**UNITED STATES OF AMERICA
BEFORE THE
FEDERAL ENERGY REGULATORY COMMISSION**

Docket No. RM16-1-000

**COMMENTS OF THE
NORTH AMERICAN ELECTRIC RELIABILITY CORPORATION
IN RESPONSE TO NOTICE OF PROPOSED RULEMAKING**

Proposal to Revise Standard Generator Interconnection Agreements

Figure 2: Proposed Non-Synchronous Generation Reactive Power Capability Curve

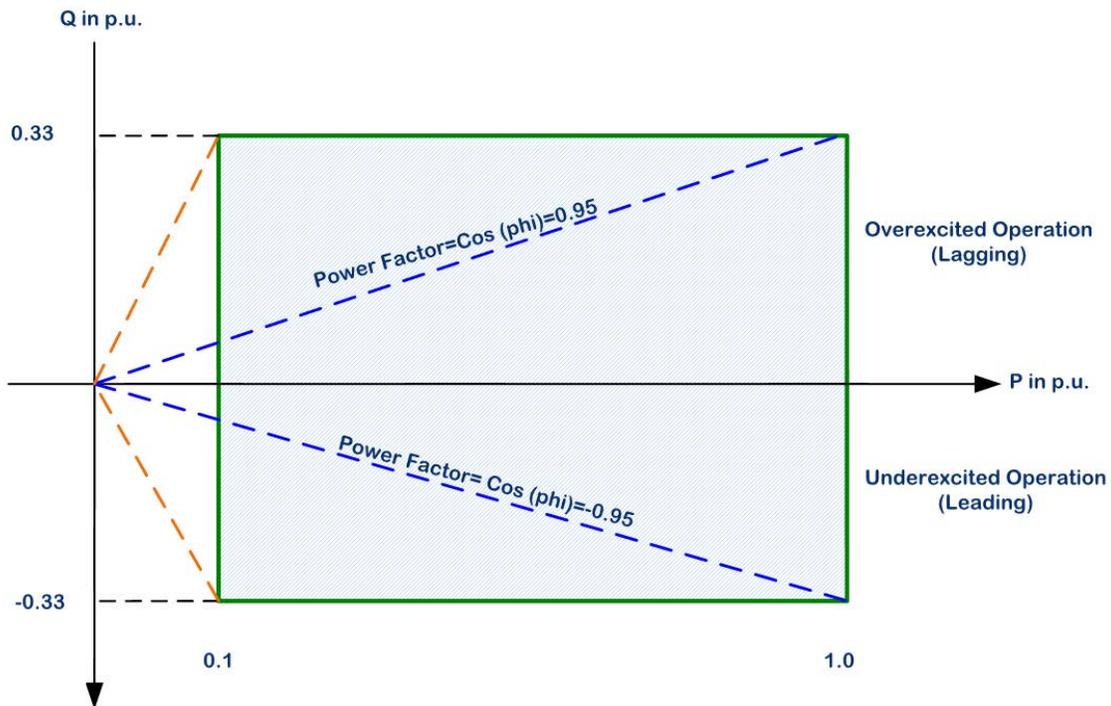
Figure 2 depicts the reactive capability for the required power factor range of 0.95 leading to 0.95 lagging. The non-synchronous generating facility must be able to provide reactive capability over full range of real power output down to 10% of rated power. The reactive capability bounds are determined by calculating the reactive power output for a ± 0.95 power factor, as shown by the green box in Figure 2. The blue lines in Figure 2 specify the reactive power production or consumption if operated in a constant power factor

mode. NERC interprets the FERC NOPR to require this type of reactive capability, and agrees with this approach assuming that POI voltage is addressed as described below.

Figure 4: Reactive Capability Corresponding to POI Voltage [Source: CAISO⁷]

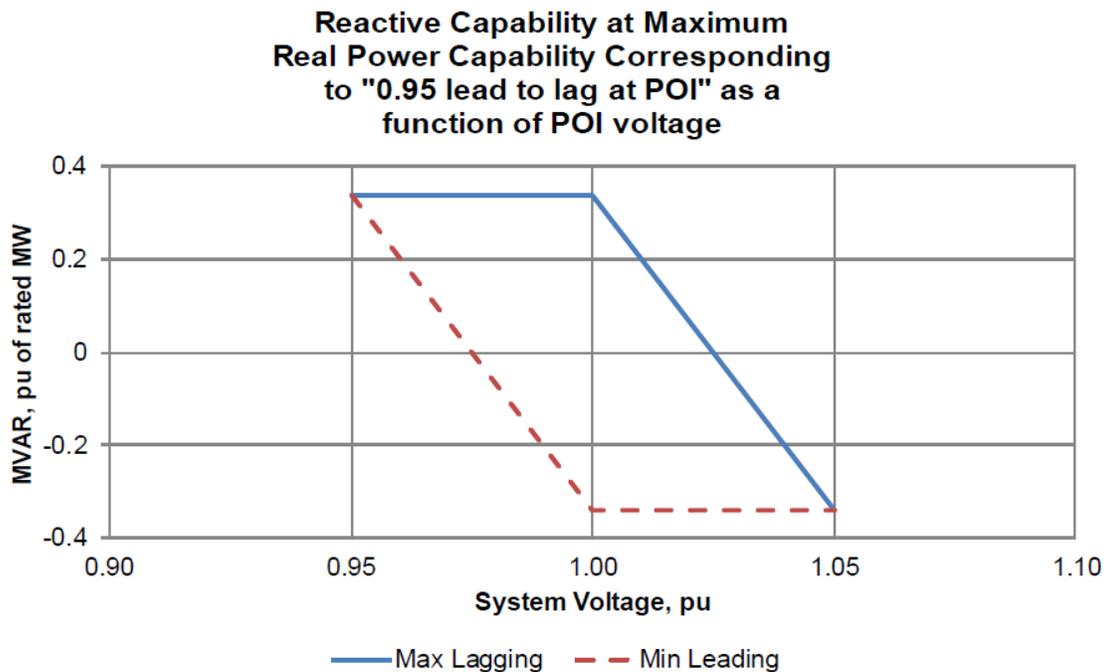
The specification of 0.95 leading to 0.95 lagging power factor at full active power output proposed by FERC is slightly ambiguous because it does not address Point of Interconnection (POI) voltage. Terminal voltage limitations of the units can affect reactive power capability and therefore a reactive power versus voltage characteristic should be used in conjunction with the capability specification. Figure 4 shows an example of this Q vs. V capability curve. The non-synchronous power plant must have the capability to provide reactive power at 0.95 lagging when voltage is between 0.95 - 1.0 pu at the POI. Similarly, the non-synchronous power plant must have the capability to absorb reactive power at 0.95 leading when voltage is between 1.0 - 1.05 pu. Capability to provide reactive power decreases as voltage at the POI exceeds 1 pu; capability to absorb reactive power decreases as voltage at the POI drops below 1 pu. This is used as an illustration and may need to be adapted by Transmission Providers dependent on voltage schedule needs (e.g., based on POI voltage level).

NERC Position: NERC agrees with the requirement for non-synchronous generation to comply with providing a “composite power delivery at continuous rated power output at the Point of Interconnection at a power factor within the range of 0.95 leading to 0.95 lagging, unless the Transmission Provider has established different requirements that apply to all similarly situated generators in the control area on a comparable basis.” Review of inverter-based non-synchronous generation has identified that modern Wind Turbine Generator (WTG) technology can provide the full range of required power factor capability when online. For situations where the WTG itself cannot meet the full power factor requirements, dynamic reactive devices such as STATCOMs or SVCs can be employed to expand reactive capability. However, it is unclear what the power factor requirement refers to explicitly with respect to power factor capability at active power outputs other than nominal. It is assumed that the non-synchronous generation must meet the 0.95 leading to 0.95 lagging power factor capability using continuously-acting dynamic reactive resources for all real power outputs above 10% of nominal. This assumes a “box”-type reactive capability range. FERC should clarify this using a reactive capability diagram for non-synchronous generation plants, as measured at the Point of Interconnection (POI). In addition to the reactive capability curve, a complete specification should address the expected capabilities during off-nominal voltages. Non-synchronous generation may not, and should not necessarily, be required to provide full capability range at all operating voltages (e.g., a generator should not be required to provide full reactive power consumption when low voltage conditions are occurring at the POI). A reactive capability versus voltage characteristic would clearly address this issue and is recommended.

Figure 5: Proposed Non-Synchronous Generation Reactive Power Capability Curve

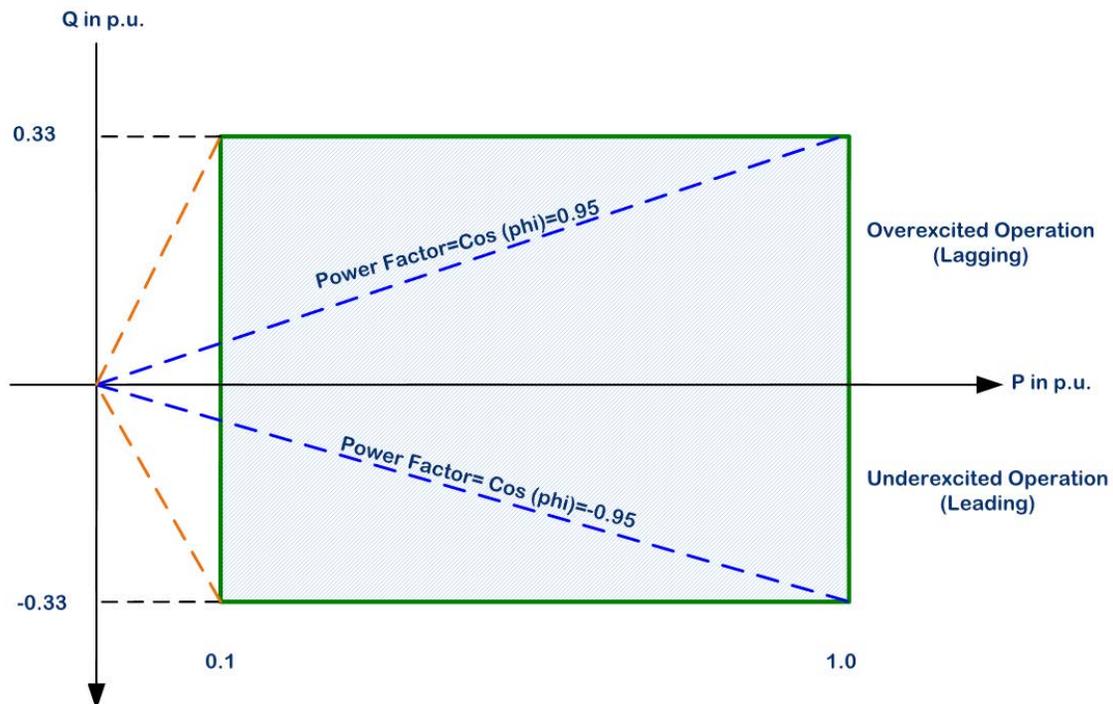
Figure 5 again depicts the reactive capability for the required power factor range of 0.95 leading to 0.95 lagging. The non-synchronous generating facility must be able to provide reactive capability over full range of real power output down to 10% of rated power.

The preceding section gives examples of actual WTGs and their capabilities, and illustrates how the WTGs themselves can provide sufficient reactive power control; however, at very low output levels it is hard for the plant as a whole to control VARs because the WTGs are cycling between power production and offline. Since all or a large portion of the generators in a wind or solar plant may be offline during periods of low output, it is difficult to meet the full range of reactive capability at low real power output levels. Therefore, a permissive reactive power range (i.e., 10% of nominal real power rating) where the plant does not have to meet the reactive power capability envelope is technically justifiable and reasonable.

NERC Position: FERC’s proposed permissive reactive power range for low real power output is technically justified and reasonable. A 10% minimum active power output level accounts for a dispersed power producing resource such as wind or solar not being able to provide full capability range due to cycling individual units. At low output, some WTGs or PV inverters may be offline resulting in a reduction of reactive capability. Therefore, a 10% minimum active power output level accounts for this technology limitation while ensuring full dynamic reactive capability when attainable.

Figure 6: PRC-024 Low Voltage Ride Through Duration Curve

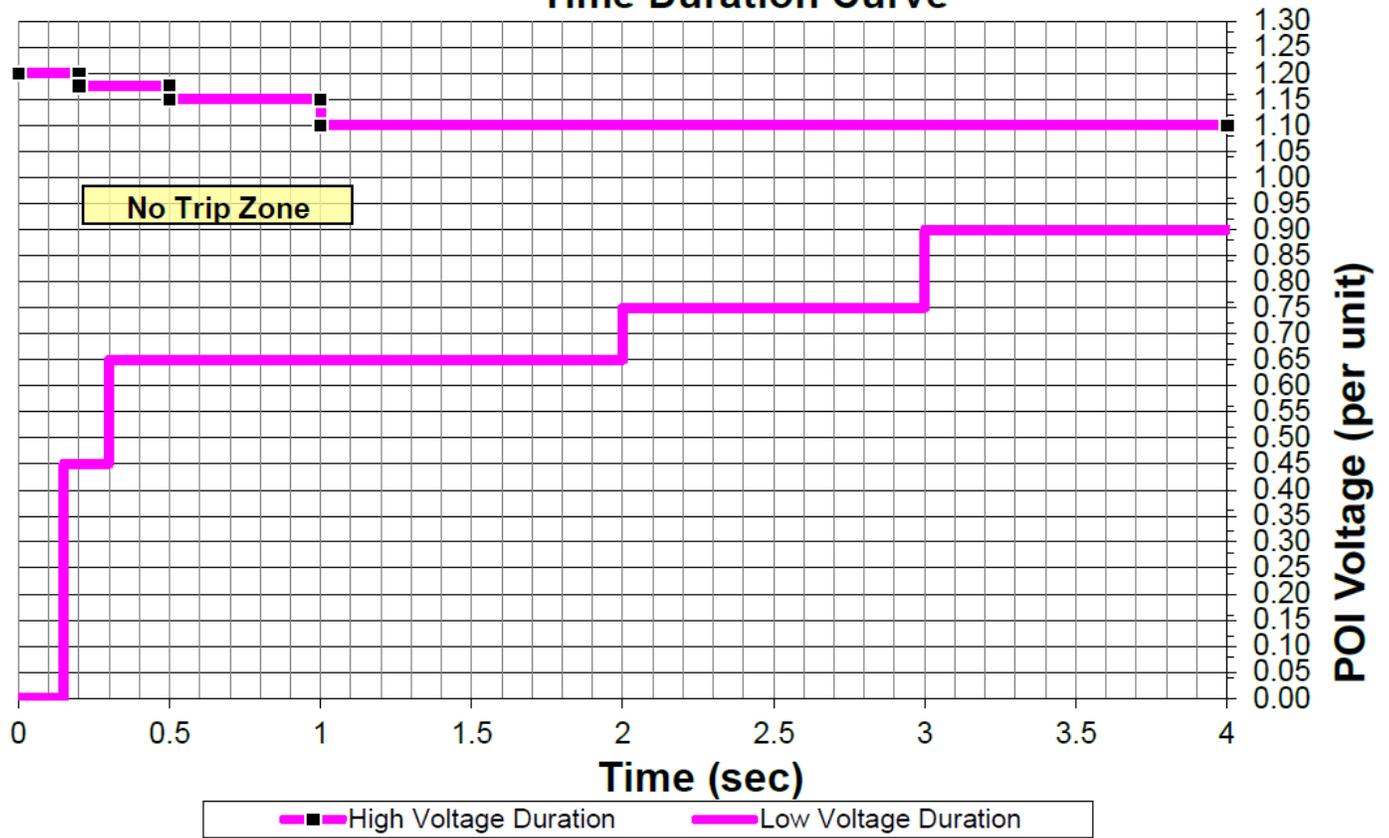
These requirements apply to all FERC-jurisdictional BES generating resources with voltage protective relays, and PRC-024 explicitly highlights the inclusion of “dispersed power producing resources identified through Inclusion I4 of the Bulk Electric System definition.” Attachment 2 of PRC-024 describes the required voltage levels and durations for voltage protective relaying on the generator, and is shown in Figure 6 and Table 1.

NERC Event Analysis has experienced a number of such events where the generating facility or unit was tripped due to auxiliary loads tripping, not generator protective relaying causing the disconnection. Requirements by FERC, similar to those set forth in Appendix G, for both synchronous and non-synchronous Generation Facilities regarding LVRT would ensure continuity of the BES generation.

NERC Position: Voltage ride through (VRT) is not discussed in this FERC NOPR; however, NERC sees a possible inequity with respect to Low Voltage Ride Through (LVRT) requirements for BES synchronous and non-synchronous generators. On one hand, Appendix G of the LGIA, applicable only to wind plants, specifies that the Generation Facility must not disconnect for voltages and times specified as per the Appendix. This requirement ensures that the Generation Facility remains connected for expected times, regardless of what may cause it to disconnect. On the other hand, NERC Reliability Standard PRC-024 applies to all BES generators, including wind and solar facilities that are BES Elements; however, it only prescribes that the generator voltage protective relays must be set according to the Standard and does not address auxiliary equipment that may trip the generator offline. NERC believes that FERC may want to consider a VRT requirement, similar to Appendix G, for all Generation Facilities including synchronous generators. NERC Event Analysis has experienced a number of events where the generating facility or unit was tripped due to auxiliary loads tripping, not generator protective relaying causing the disconnection.
